BOSTON EDISON COMPANY
800 BOYLSTON STREET
BOSTON, MASSACHUSETTS 02199

License No. DPR-35
Docket No. 50-293

Supplemental Response to IGSCC
Inspection Order Confirming Shutdown

- Reference: (a) Boston Edison Company Letter (W. D. Harrington) to NRC (H. R. Denton), dated September 11, 1984
- Attachments: (1) Isometric Drawing ISI-I-10-1
(2) Pilgrim Nuclear Power Station - Recirculation Nozzle Repair Program and Hydrogen Water Chemistry Materials Qualification

RHR RETURN LINES
LOOPS A & B

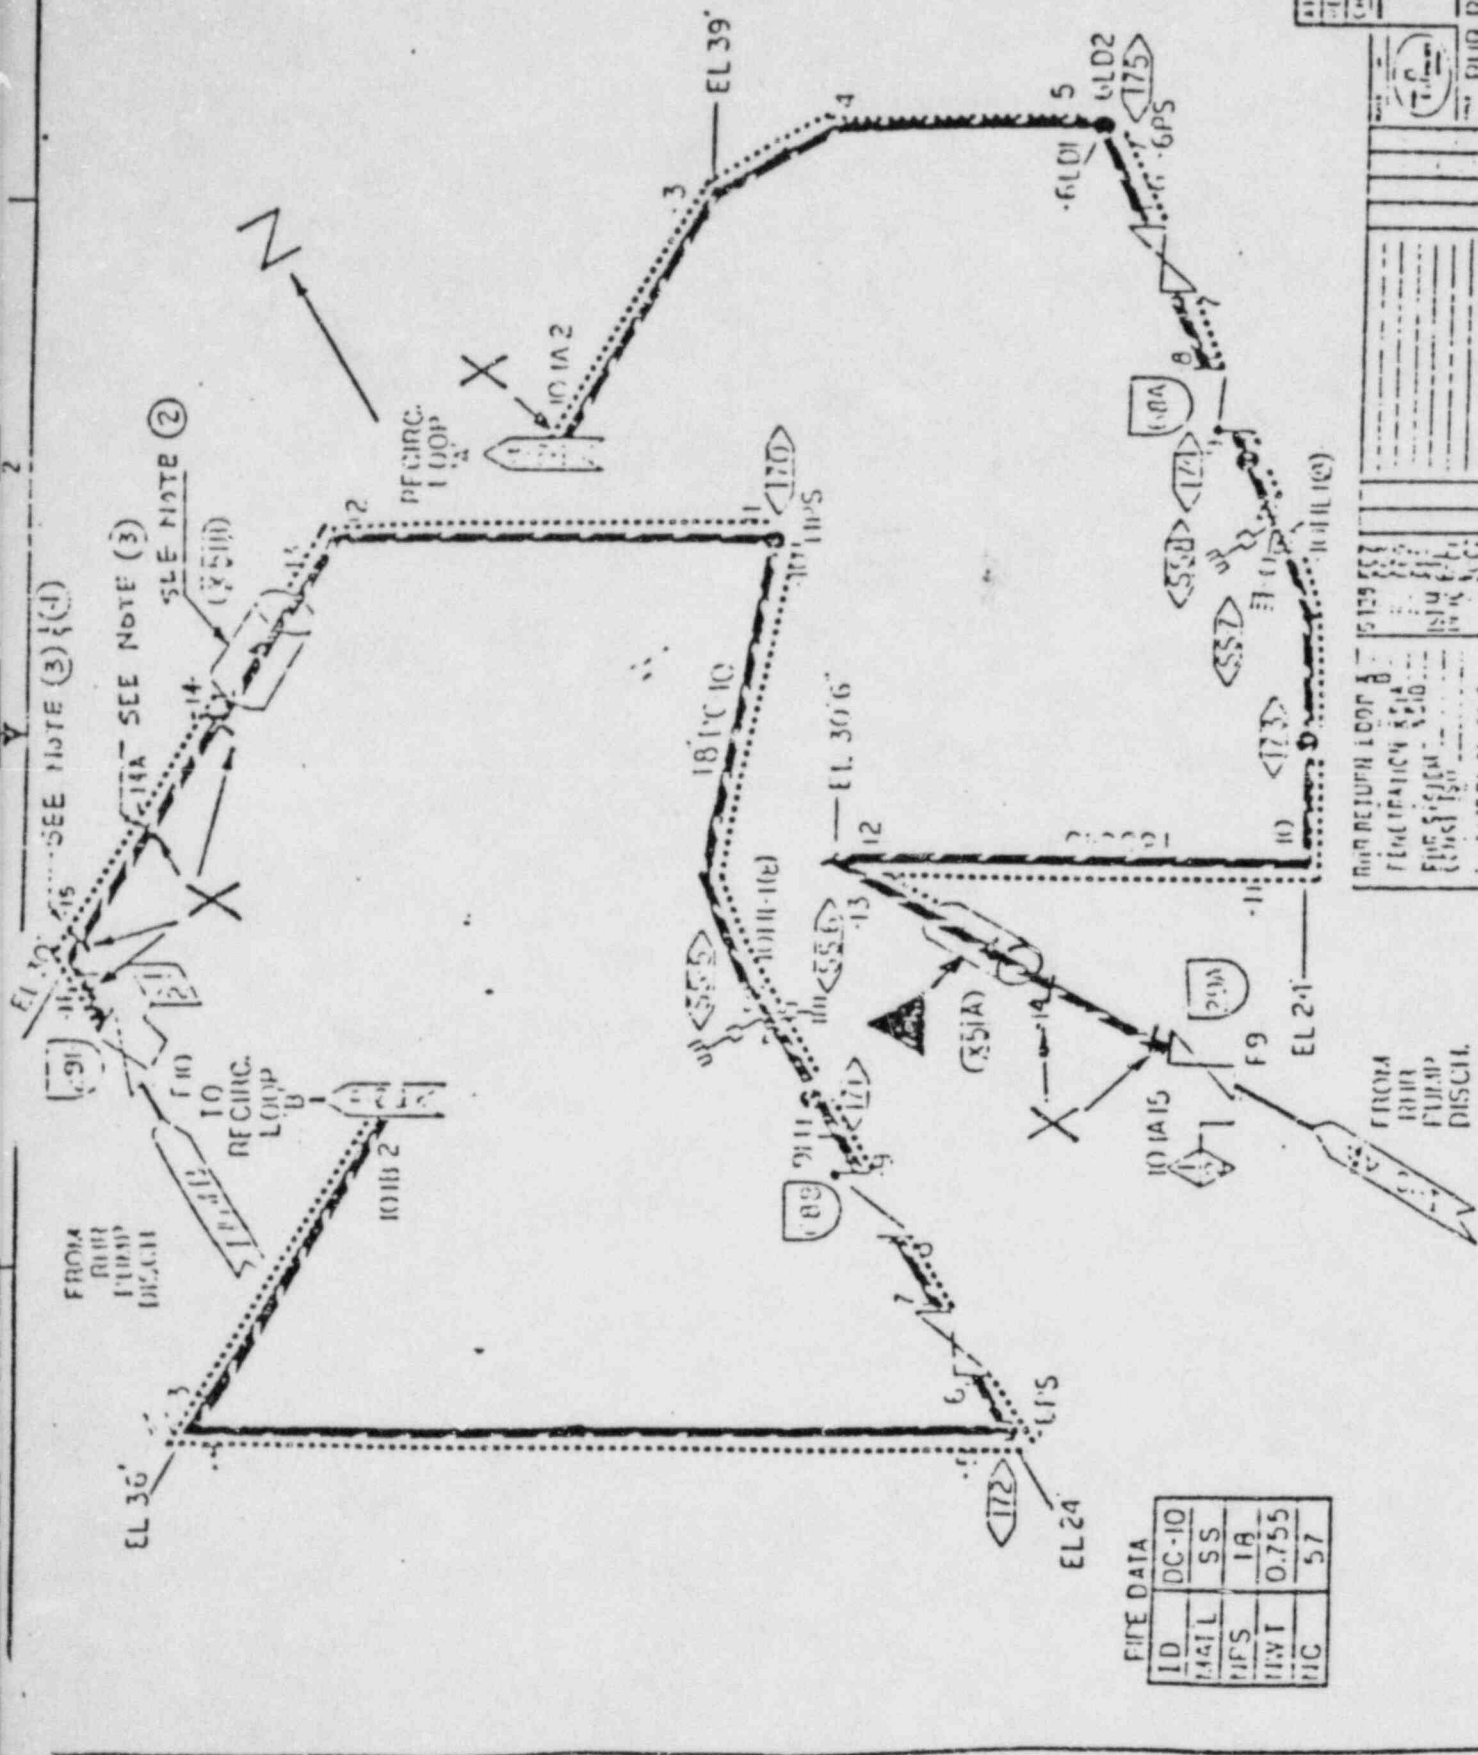
Third, isometric drawing ISI-I-10-1 originally showed that the portion of line from penetration X-51A to valve 29A will be replaced with 316 NG stainless steel material. This portion of line will not be replaced and never was intended to be replaced. A corrected drawing is enclosed (Attachment 1) in this submittal.
